ENGINE – ELECTRICAL POWER – IDG OIL COOLING TUBES – MODIFIED SUPPORT BRACKET FOR CLIP
POINT 1072 – CATEGORY CODE 6 – MOD.ENG-24-0004

V2500-ENG-24-0004

SERVICE BULLETIN

View on fuel cooled IDG oil cooler - Before and after alteration
Fig.2

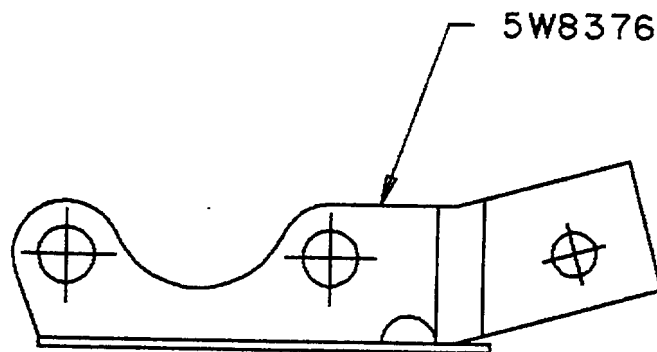
It has been found on build that a foul may occur between the support bracket for Clip Point 1072 and the IDG oil cooler oil outlet tube adaptor.

The support bracket was designed to suit the forged adaptor but a foul may occur with the machined adaptor due to the different profile.

This Service Bulletin introduces a new bracket to improve clearance with machined adaptors.

This Service Bulletin introduces a support bracket which is identical to the existing bracket but for a revised profile between the fixing holes.

View on arrow AB showing bracket - Before and after alteration
Fig.3

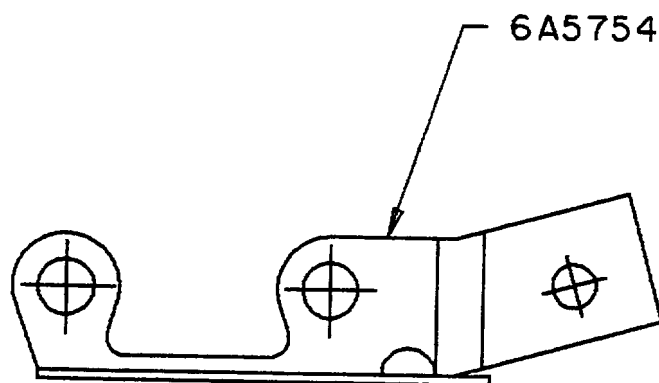
VIEW ON ARROW **AB** SHOWING BRACKET
BEFORE ALTERATION
SHOWN THUS FOR CONVENIENCE

VIEW ON ARROW **AB** SHOWING BRACKET
AFTER ALTERATION
SHOWN THUS FOR CONVENIENCE

Reworking of existing bracket
Fig.4

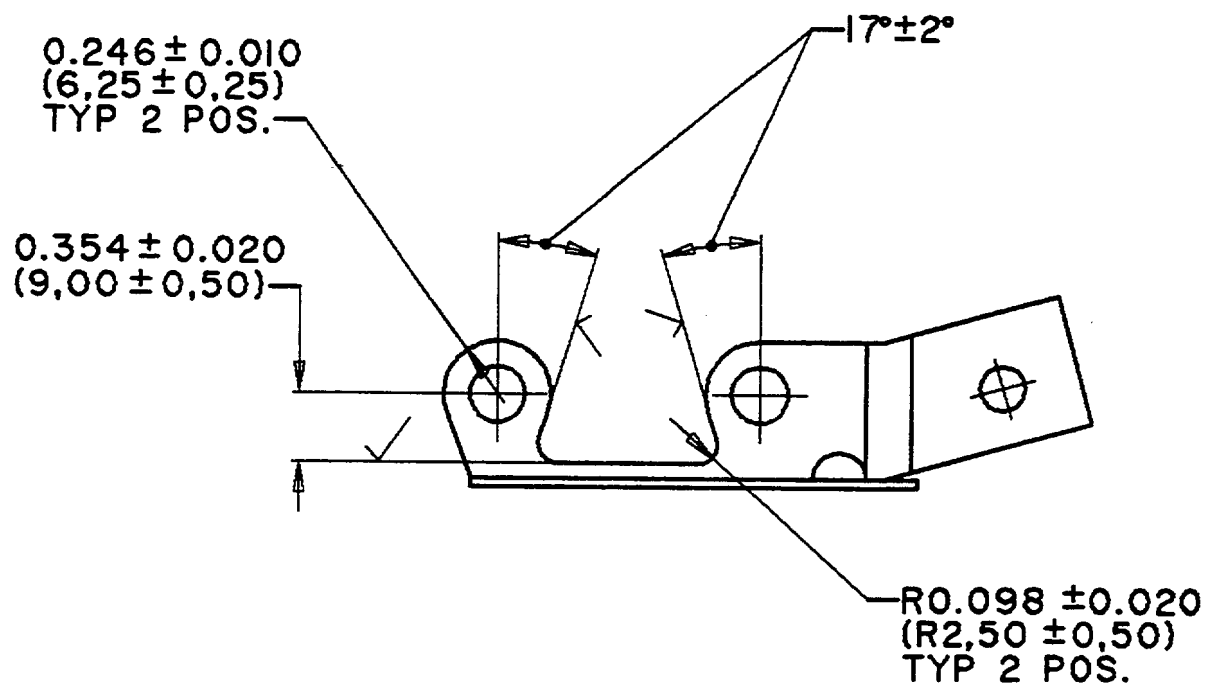
| (b) Apply marking ink to the area(s) for rework | See Figure 4. Use CoMat 02-124 marking ink. Use standard workshop equipment |
| (c) Mark the rework area(s) | See Figure 4. Use locally manufactured template with a scribing tool. |
| (d) Remove the unwanted material | See Figure 4. Use standard workshop equipment |
| (e) Visually examine and measure the dimensions of the support bracket | See Figure 4. Use standard workshop equipment |

Re-number

5W8376

6A5754
